**ADDENDUM TO PERMIT ENGINEERING EVALUATION**  
**Dated September 30, 2010 for**  
**Dominion – Warren County Power Station**  
**Registration 81391**

Subject: Virginia Department of Environmental Quality (DEQ) Technical Review of the Air Quality Analyses in Support of the PSD Permit Application for the Proposed Dominion Natural Gas-Fired Power Plant in Warren County, Virginia (Warren County Power Station)

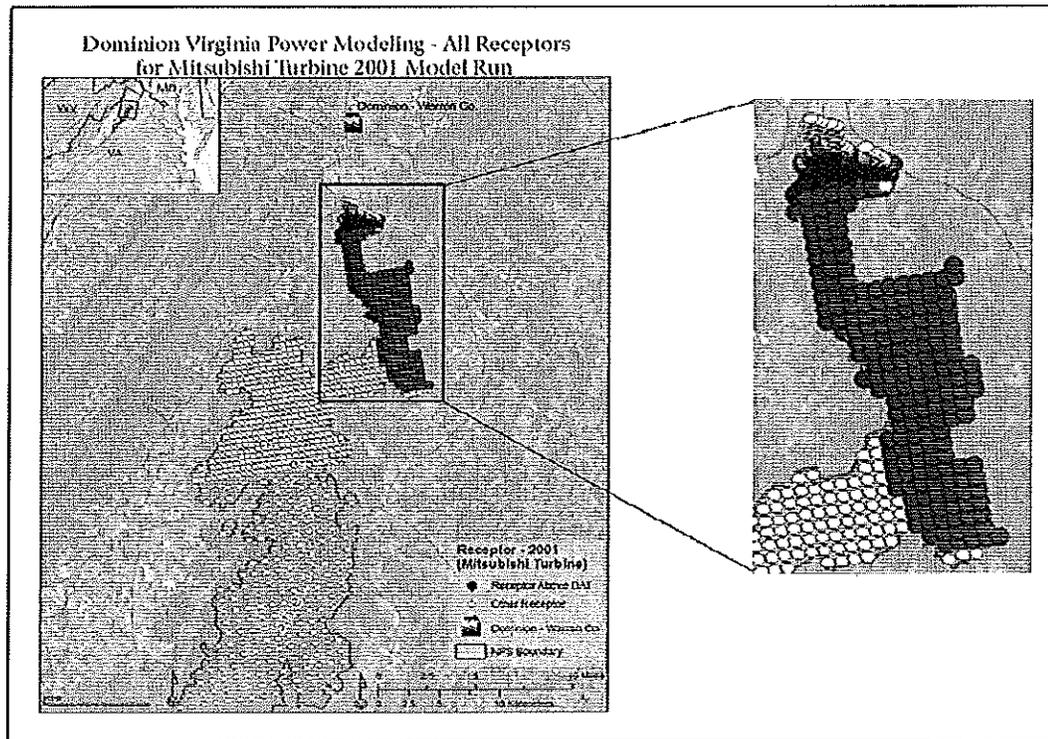
The NPS has expressed concern that locations within the northern end of the SNP had predicted nitrogen deposition greater than 0.020 kg/ha/yr, a value more than twice the DAT. The following figure illustrates the receptors with modeled impacts greater than the DAT. The maximum modeled nitrogen deposition at any receptor was 0.022 kg/ha/yr.

DEQ agrees additional nitrogen deposition resulting from emissions from the proposed project may adversely impact streams and aquatic biota already impaired because of acidification. The NPS comments do not specifically quantify what impact a loading of 0.022 kg/h/yr (maximum receptor) would have on a stream's pH. DEQ also supports a modeling approach which averages impacts across an individual watershed as opposed to the standard NPS practice of using the maximum impact at any one receptor to determine significance.
